Access Compliance Report

Public Rights-of-Way

Intersection ID: 29174	Main Street: BIG_LEAF_DR	Cross Street: CHRUDAN_DR	Location: SE
ADA ID: 296DB8AC7C89	Ramp Type: PerpDiag	Initial Pass/Fail: Fail	Overall Compliance: No
Severity Score: 10			
Codes/Mitigation Info/Possible Solution		Field Measurements/Component Compliance

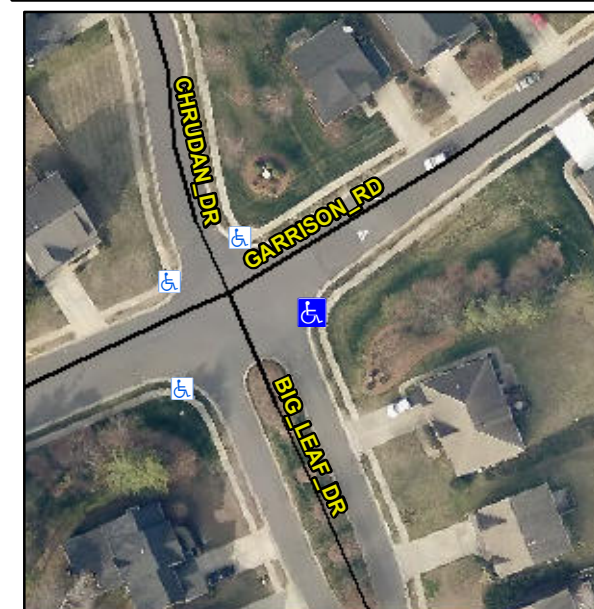
Not Found, R304.5.1, R304.5.3

Compliance	Description	Data	Compliance	Description	Data
N/A	Ramp Length (in)	49.5	Yes	Ramp Slope (%)	5.6
No	Ramp Width (in)	42.5	No	Ramp XSlope (%)	3.5
N/A	Flare Type LT	N/A	N/A	Flare Type RT	N/A
N/A	Flare Slope LT (%)	N/A	N/A	Flare Slope RT (%)	N/A
N/A	Flare Traversable LT?	N/A	N/A	Flare Traversable RT?	N/A
N/A	Landing Length (in)	N/A	N/A	DWS Provided?	N/A
N/A	Landing Width (in)	N/A	N/A	DWS Contrast?	N/A
N/A	Landing Slope (%)	N/A	N/A	DWS Length (in)	N/A
N/A	Landing X Slope (%)	N/A	N/A	DWS Full Width?	N/A
N/A	Landing Curb? (Y/N)	N/A	N/A	DWS Offset (in)	N/A
N/A	Shared Landing?	N/A			
N/A	Gutter Ponding?	N/A	N/A	Gutter Slope (%)	N/A
N/A	Gutter Lip Ht (in)	N/A	N/A	Gutter X Slope (%)	N/A
N/A	Painted X Walk1?	No	N/A	Painted X Walk2?	No
	X Walk 1 Direction	To N		X Walk 2 Direction	To W
N/A	X Walk 1 Width (in)	N/A	N/A	X Walk 2 Width (in)	N/A
	X Walk 1 Slope (%)	4.0		X Walk 2 Slope (%)	5.0
	X Walk 1 X Slope (%)	0.1		X Walk 2 X Slope (%)	7.9

N/A	Ramp inside XWalk1?	N/A	N/A	Ramp inside XWalk2?	N/A
	Road Slope (%)	2.8	N/A	Clear Space?	N/A
	Road X Slope (%)	9.0	N/A	Clear Space to XWalk (in)	N/A
N/A	Any Obstructions?	N/A	N/A	Storm Grate/Utility Hazard?	N/A
	Obstruction Type			Storm Grate/Utility Type	
		N/A			N/A
		Yes		Surface Condition? (G/P)	Good

Remove & Replace Curb Ramp With Two New Directional Ramps or Equivalent.
